Architectural Review and
Historic Preservation Board
Agenda Report

Meeting Date 06/02/2021

File: AR 20-18

RE: Architectural Review 20-18 (AMPM Gas Station);
A portion of APN 006-690-022

A301
 Attachment F

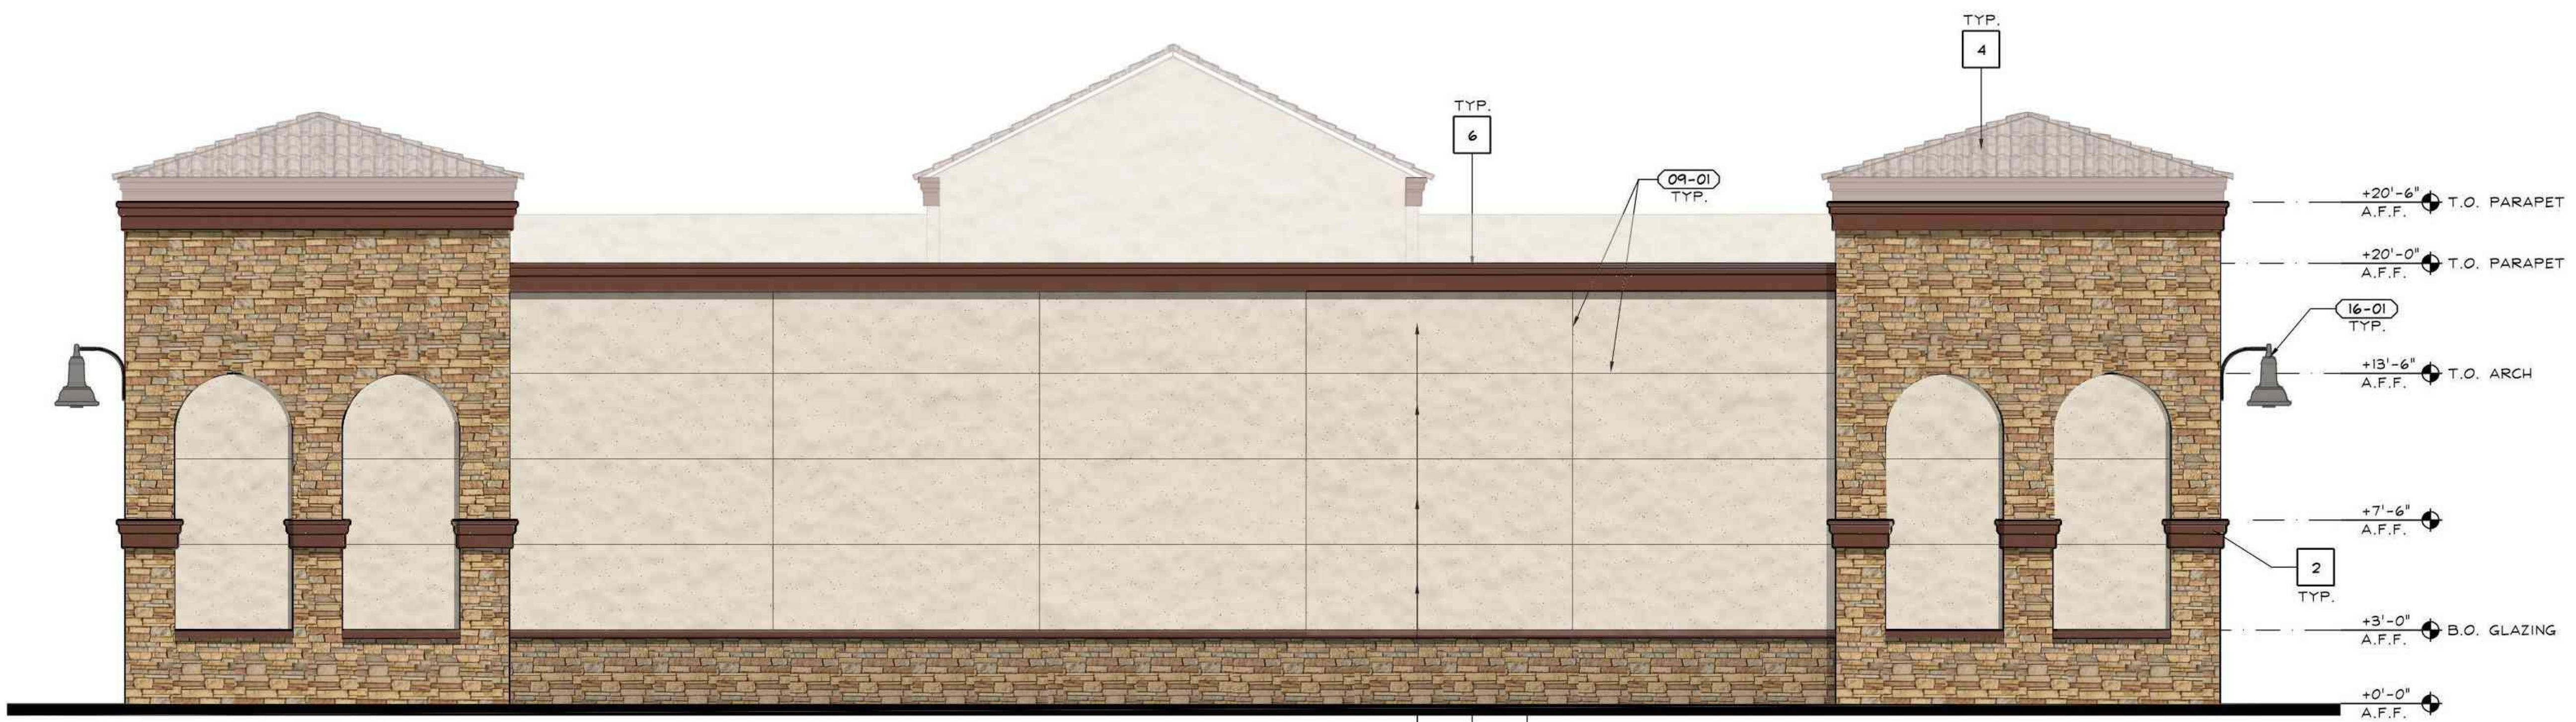
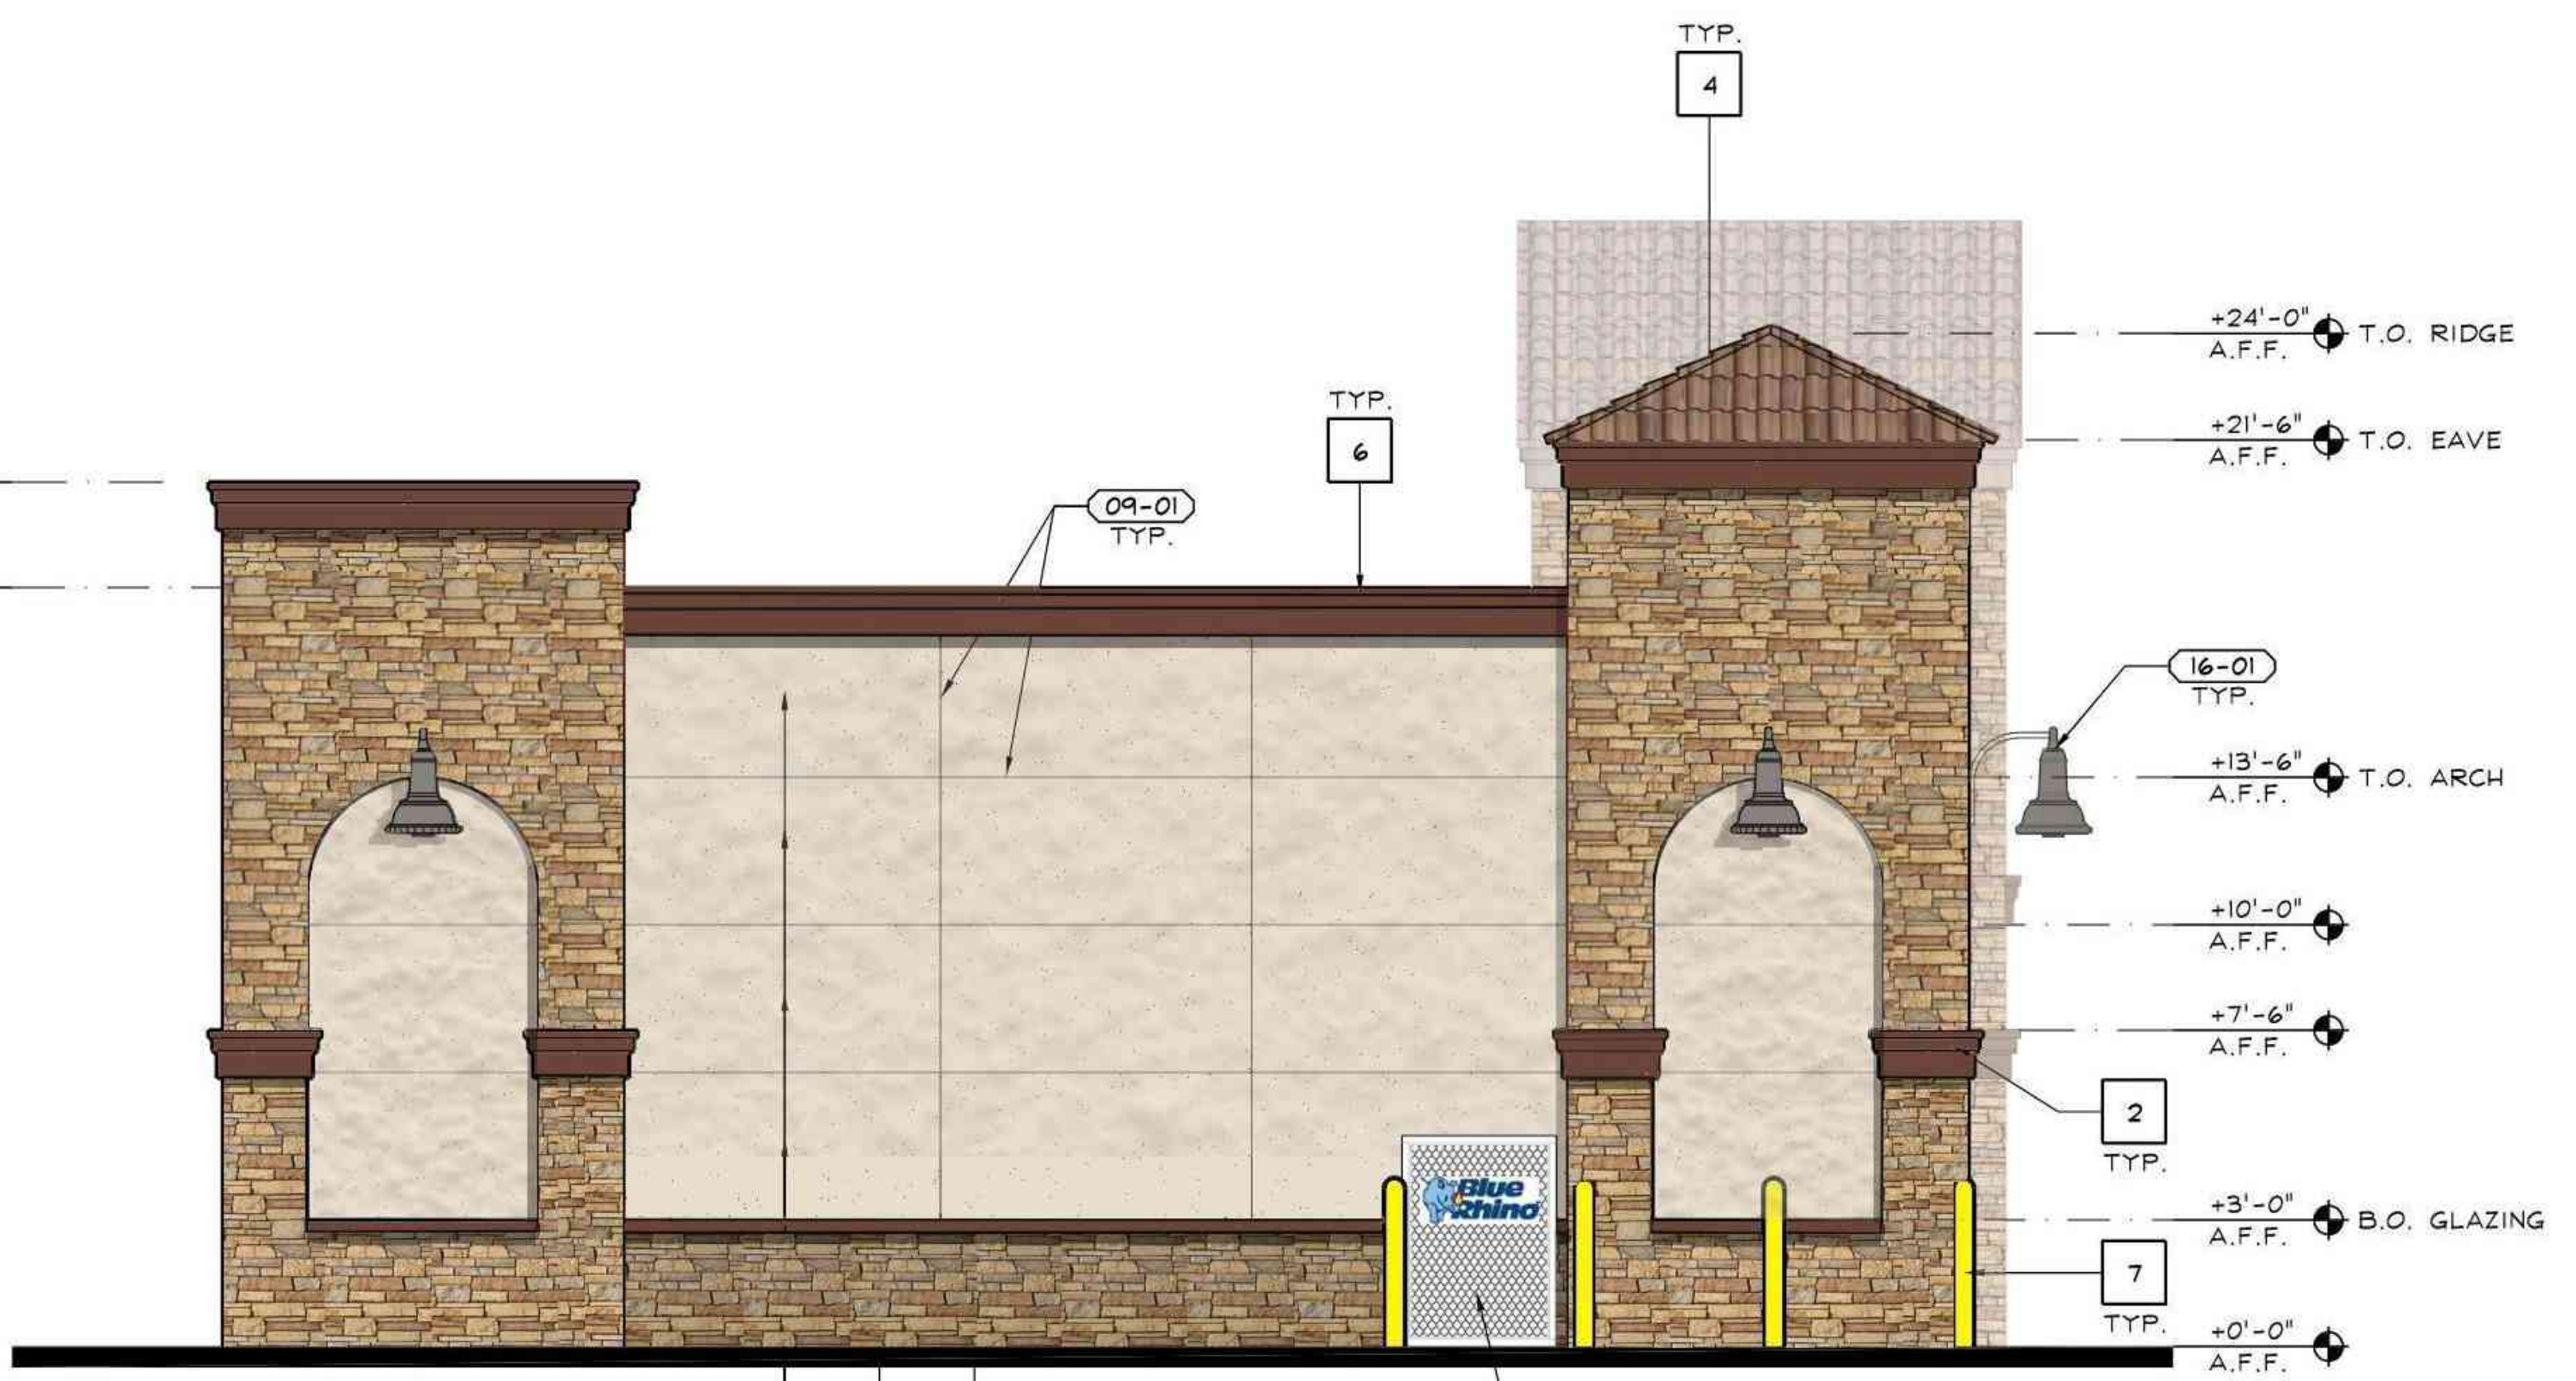
6. Wall-mounted trellis panels with climbing vines shall be incorporated on the rear (south) and east side elevations of the proposed convenience store building, and on the north side of the trash enclosure. These features shall be shown on the final landscaping plan to be submitted with building plans.
